FINAL SAFETY EVALUATION BY THE OFFICE OF NUCLEAR REACTOR REGULATION

TOPICAL REPORT ANP-10297P, REVISION 0

“THE ARCADIA® REACTOR ANALYSIS SYSTEM FOR PWRs

AREVA NP, INC.

Figure 1: Representative Axial Power Shape with Grid Depressions

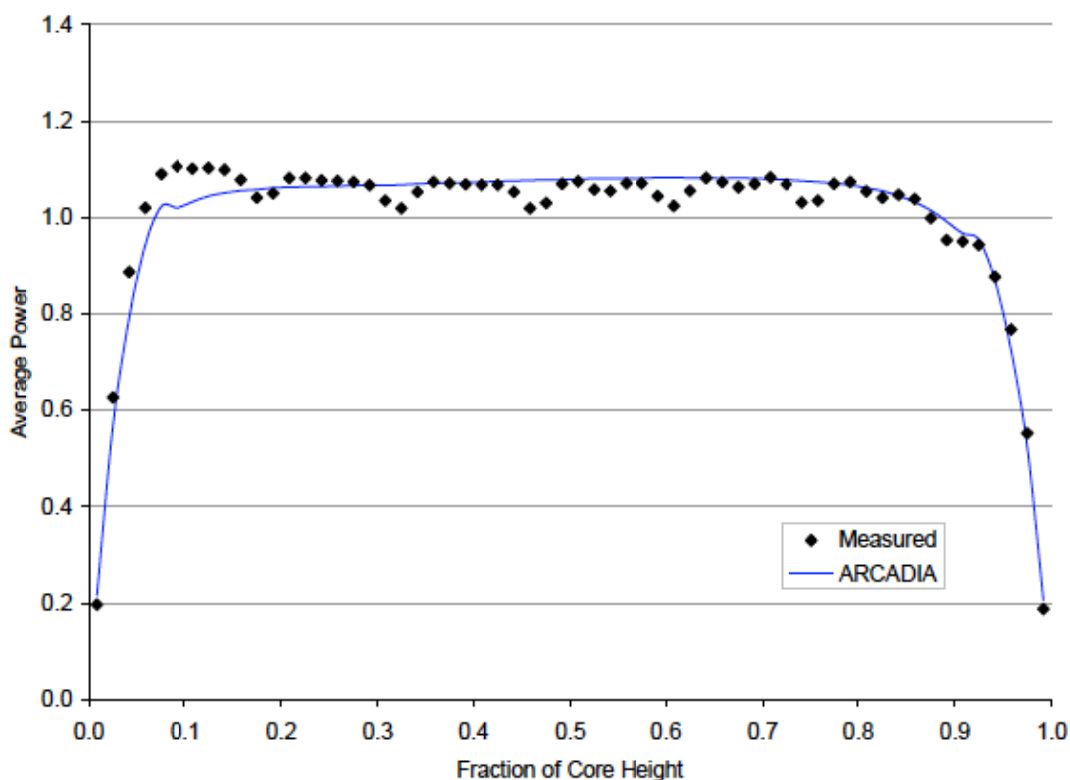
As expected the measured average axial power shapes have the similar axial power shape in all plants. A representative profile is shown in Figure 1. The grid spacer effects (grid depressions) seen on Figure 1, is common in axial power profiles of all plants except plant C and plant T. The plants C and T exhibit axial power shapes similar to the profile depicted in Figure 2. The smooth axial shape suggests that the power profile plots are not obtained from the actual detector readings but from reconstructed power shapes detector readings. However, the TR does not provide any information regarding the detector type or the power reconstruction method used in plant benchmarks. Consequently, AREVA was asked to provide further details for plant data and the interpolation/extrapolation method used to reconstruct the axial power shape if fixed core detectors were used in any plants.

AREVA provided (Reference 2) a table showing the detector type used in each plant in response to the RAI. As predicted, fixed incore Rhodium detectors are used in plants C and T. After detector power coefficients are calculated, detector inferred powers are linearly interpolated for each 24 axial node for comparison with the ARTEMISTM predicted power. Based on the ARCADIA[®] benchmark results, this simple approach produces satisfactory results.

Figure 2: Representative Axial Power Shape Profile for Plants C and T

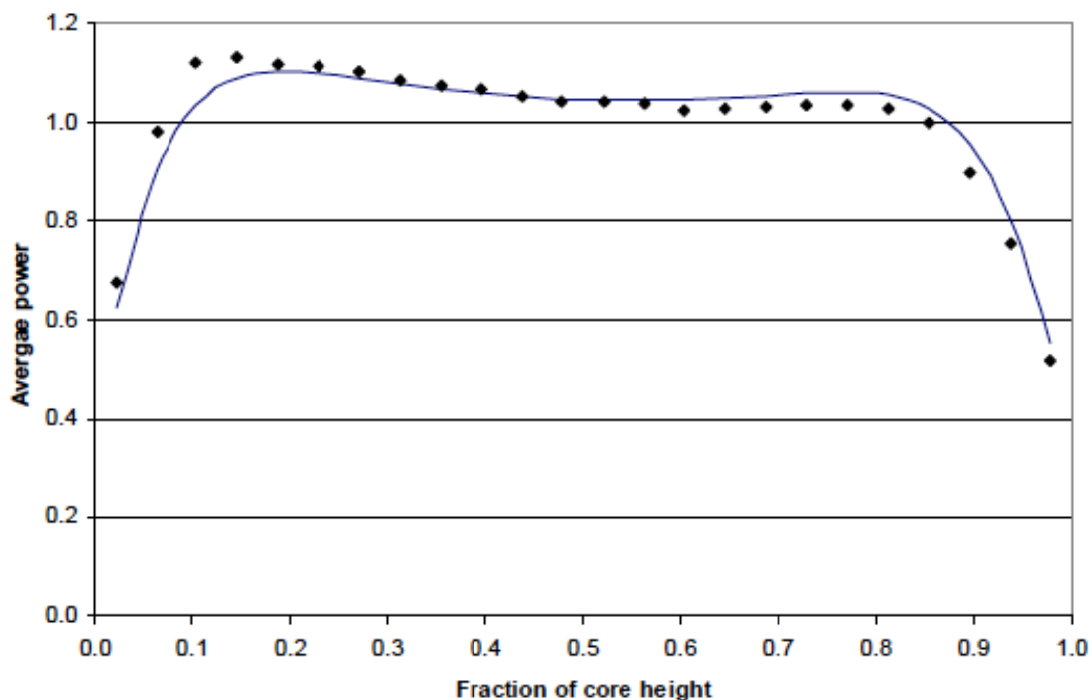
In general, when ARTEMISTM core follow benchmark results are reviewed, small trends with respect to Gd_2O_3 , U_{235} enrichments and fuel types can be seen in some cycles. However, no significant or unusual biases or trends in critical boron, assembly power and core average axial power distribution predictions were observed.
